MAEDA, K. et al.
Appl. No. 10/705,775
Amendment dated October 9, 2007
Response to Office Action dated July 9, 2007

Amendments to the Drawings:

The attached sheets of drawings include changes to Figures 11 and 20-25. These sheets replace the original sheets including Figures 11 and 20-25. In Figures 11 and 20-25, previously omitted legend "--Prior Art--" has been added.

FIG 11
 Prior Art

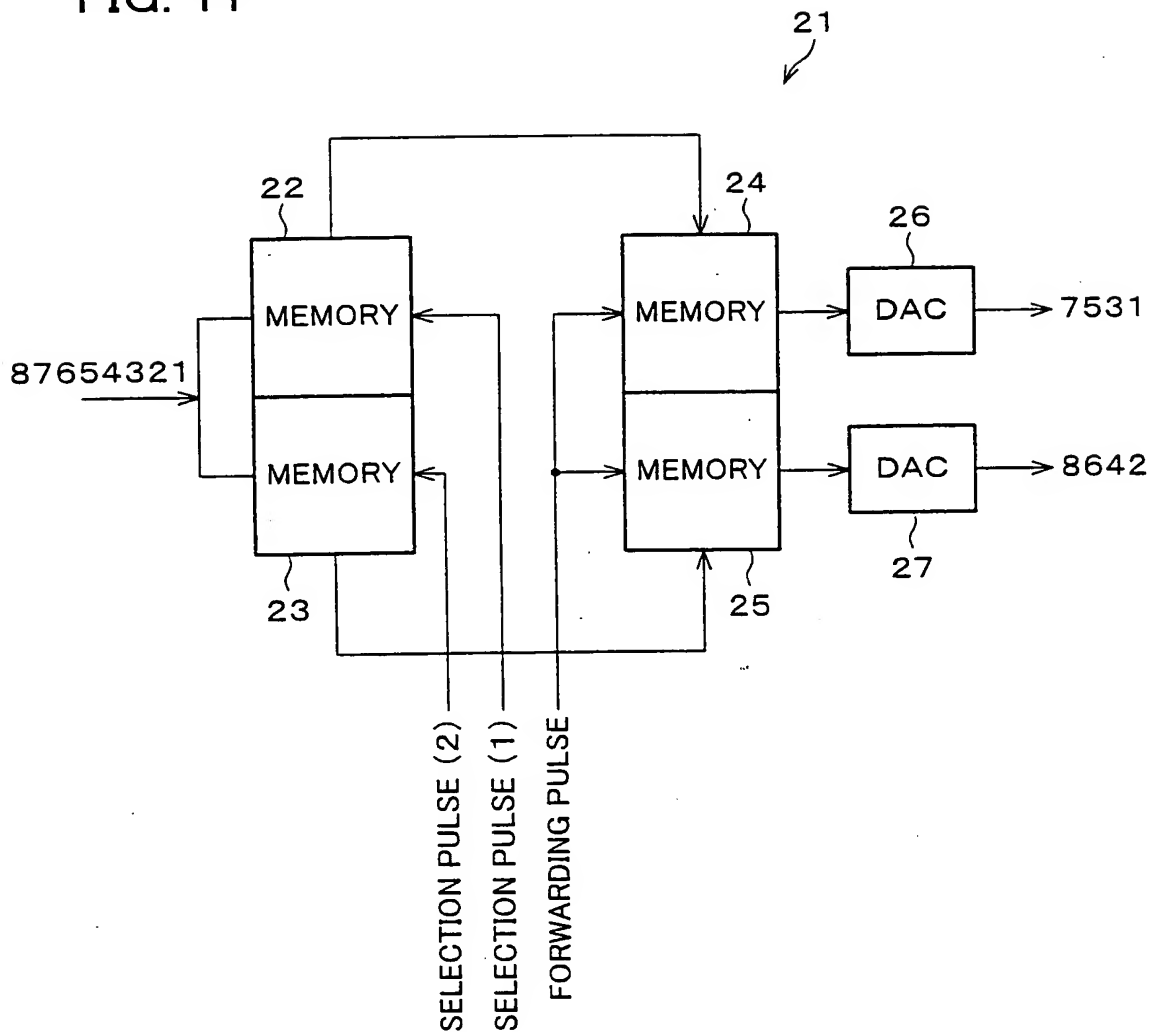
The drawings are objected to for not containing a "Prior Art" legend in Figures 11 and 20-25. The drawings have been corrected to include this legend, and the corrected drawings and annotated sheets are submitted herewith. Accordingly, reconsideration and withdrawal of the drawing objection are respectfully requested.
